## Firmware 2.06.3 bug list:

## List of bugs/improvement requests

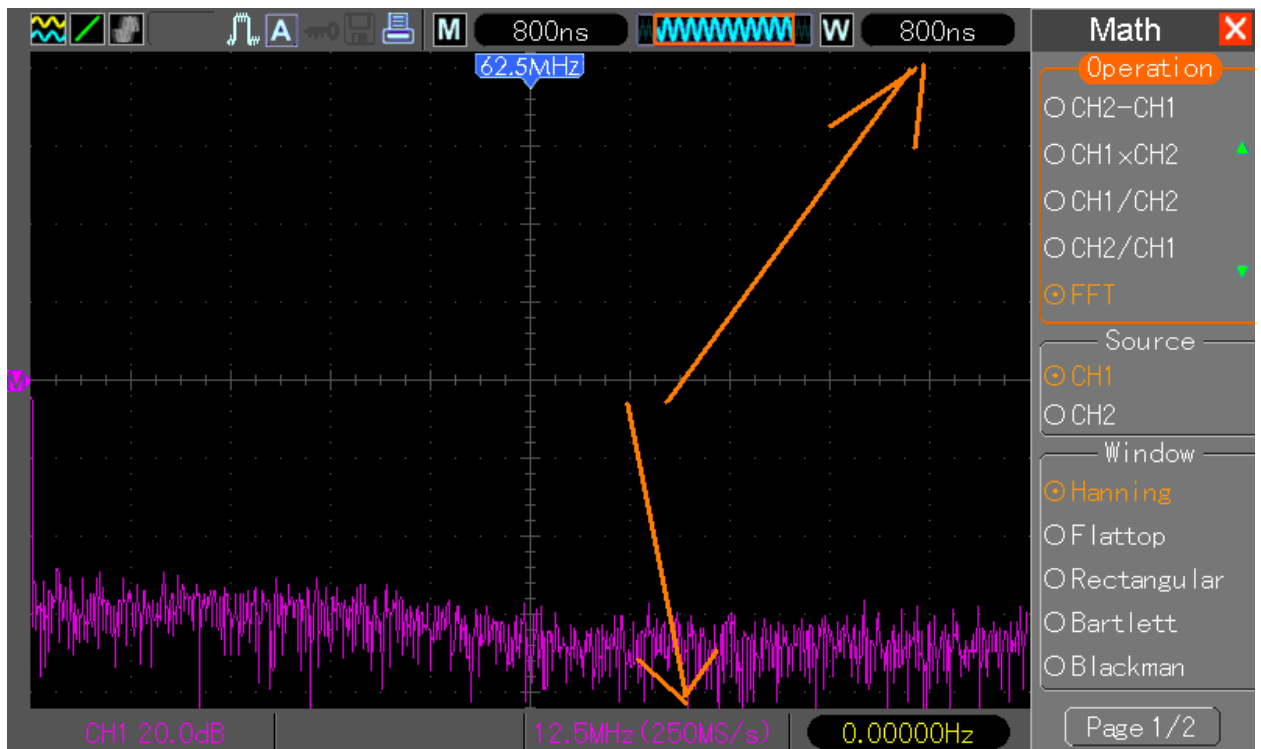
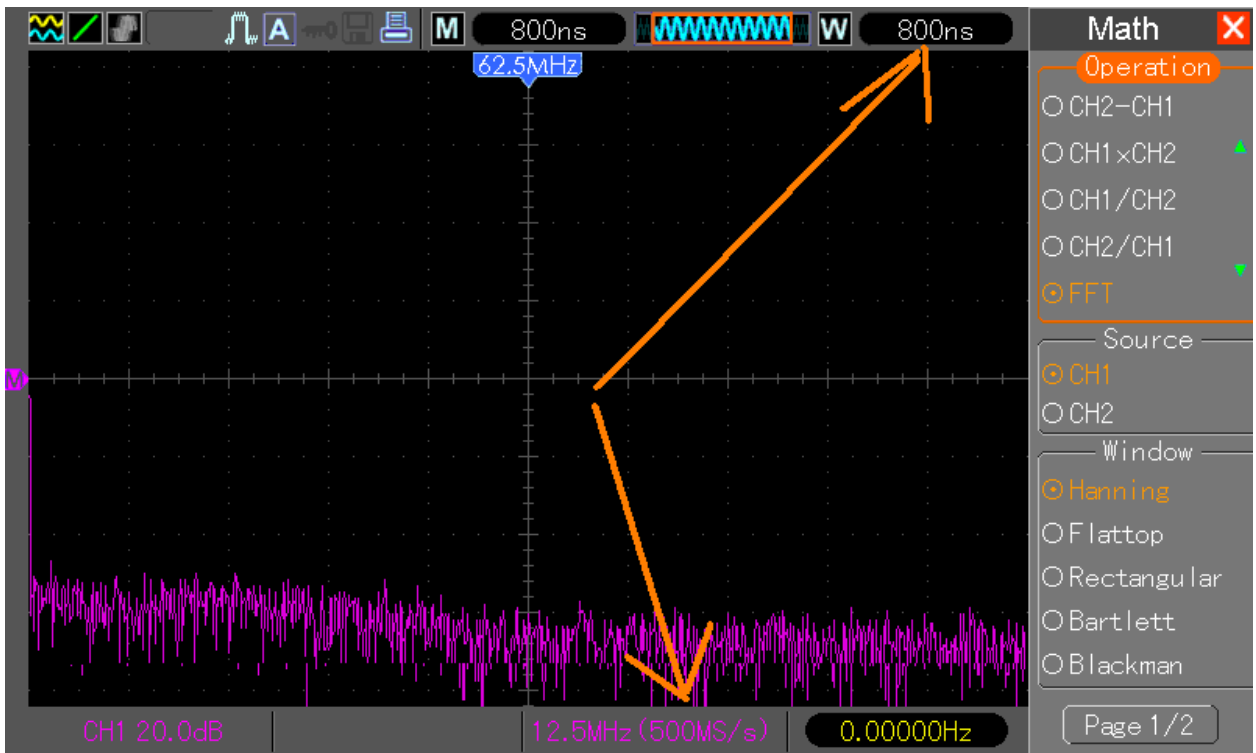
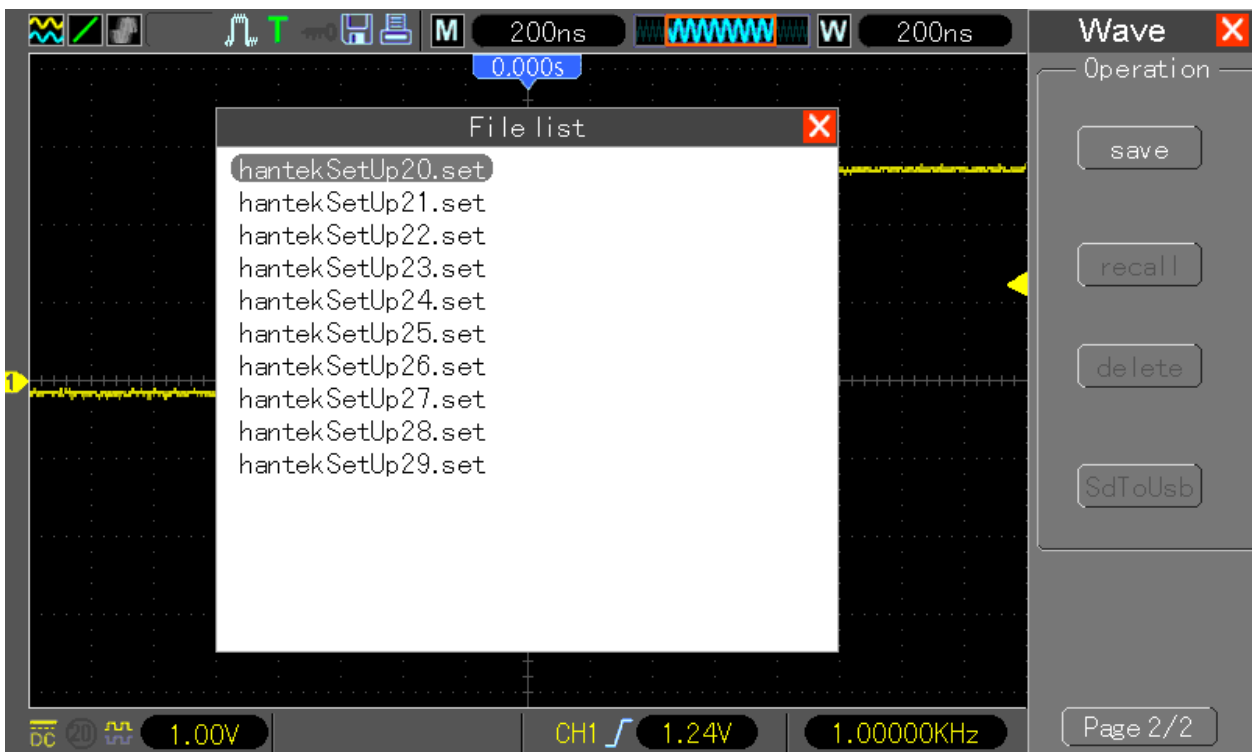
39. Within FFT the information in status bar is not always showing the proper sampling rate, sometimes even jumping from proper to bad value. As the FFT cursor is taking in count the sampling rate, the measure value might be not correct. Example random values in 800ns/DIV FFT , here 100MS/s

then 250MS/s (but still 800ns/DIV)

and here 500MS/s (but still 800ns/DIV)

36. Not a bug, but who need to see trailing zeros?
37. Turn Timebase knob one position forth and back.
38. This is funny bug, isn't?
39. Turn Timebase knob one position forth and back, in most cases the Sampling Rate within FFT will be then updated to proper value.
40. ~~Ensure that no more than 10 file on the Flash Drive.~~
